REFERENCE	BT_2014_X98CUP_02_UK
DATE	2014 Avril 15th
SUBJECT	Evolutions / options

CONCERNED : All Car

1. Front Hub bearing

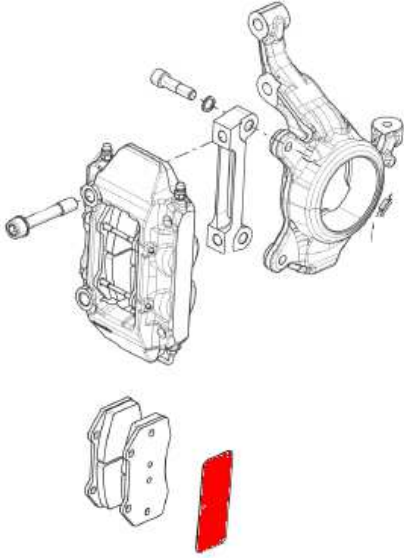
Following some bearing displacement issues, we recommend you to glue the bearing to the hub using Loctite 603 (Retaining Compound) or similar. We recommend you to use a new bearing to do this operation.

If you are not able to install the brake pad heatshields while using brand new brake pads, it is certainly because your wheel bearing as moved slightly into the upright bore.

Note: New cars delivered from Alpine from End of April will be assembled using Loctite 603 for the wheel bearings.

4. 2013 User Manuel modification – E- Chassis – Page 24/57

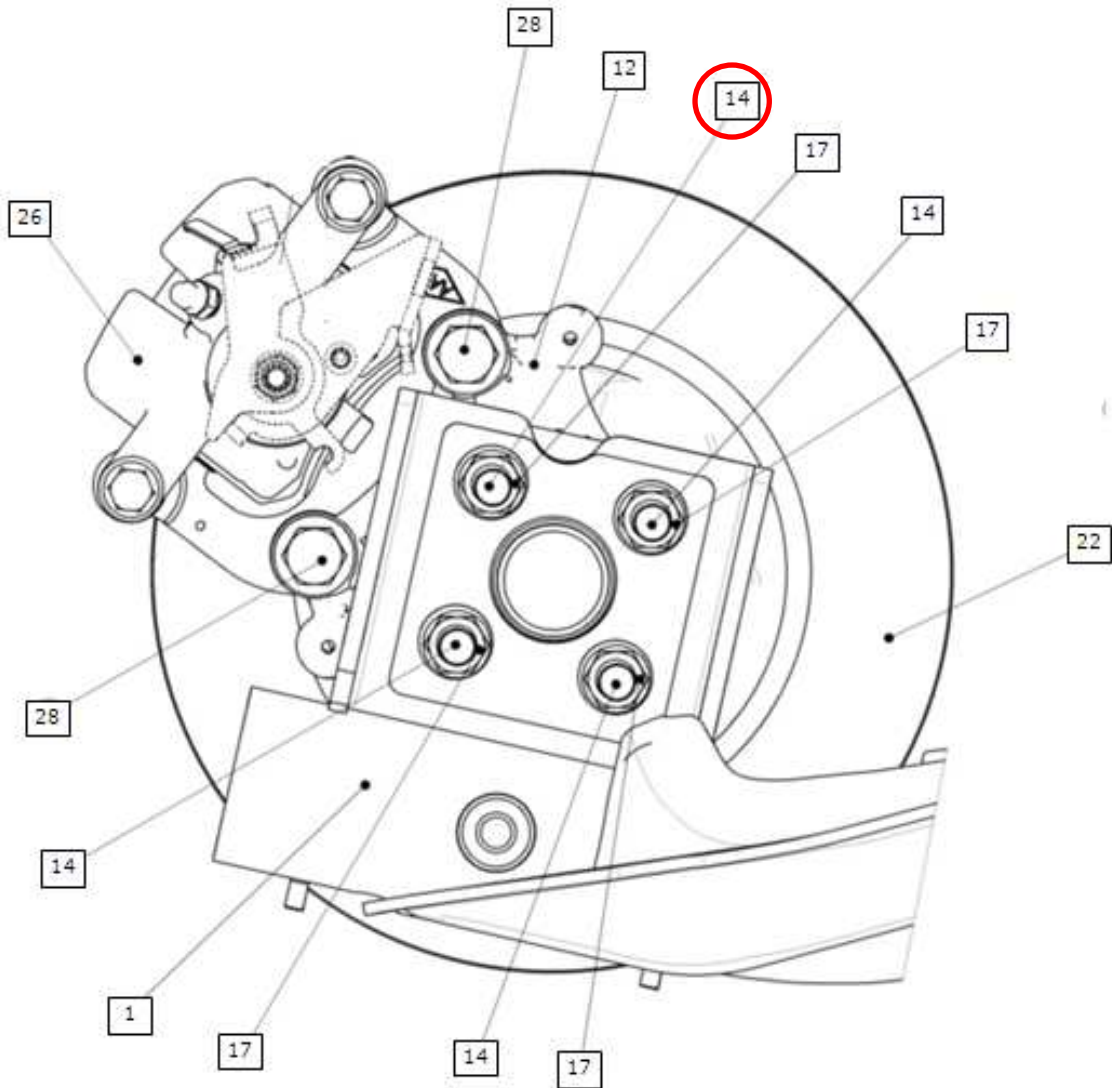
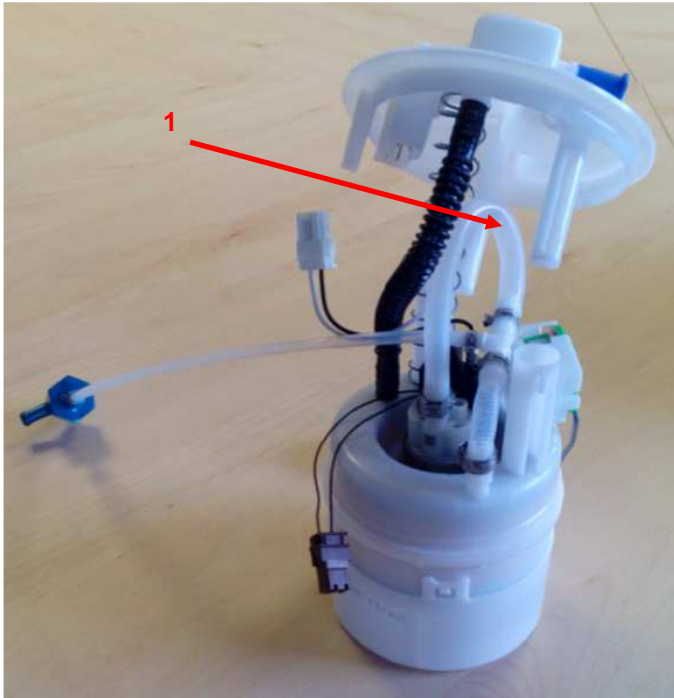
Please note that we have changed the tightening torque of the stud reference 77 11 160 567. You must now tighten the stud on the hub carrier at 50 N.m only instead of 114N.m.

14	Stud M12x80	7711160567	8	114 N.m 50 N.m	LOCTITE 270 (red)
----	-------------	------------	---	------------------------------	-------------------

5. Fuel surge Kit (Venturi) installation

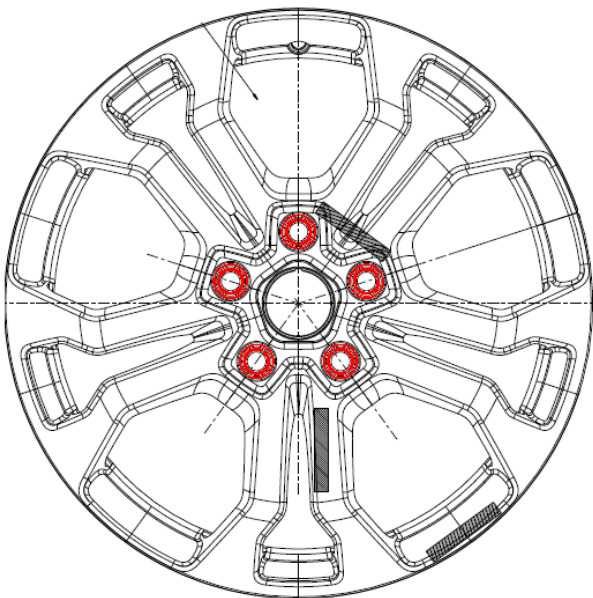
Some customers are having difficulties to install the fuel Venturi kit, particularly on the loop-shaped pipe (1), which could be pinched while re-assembling the top part of the pump onto the main body. A solution to clear this issue is under development, which is why, for the time being, the complete Venturi kit referenced **98cup00118** remains **optional** only.
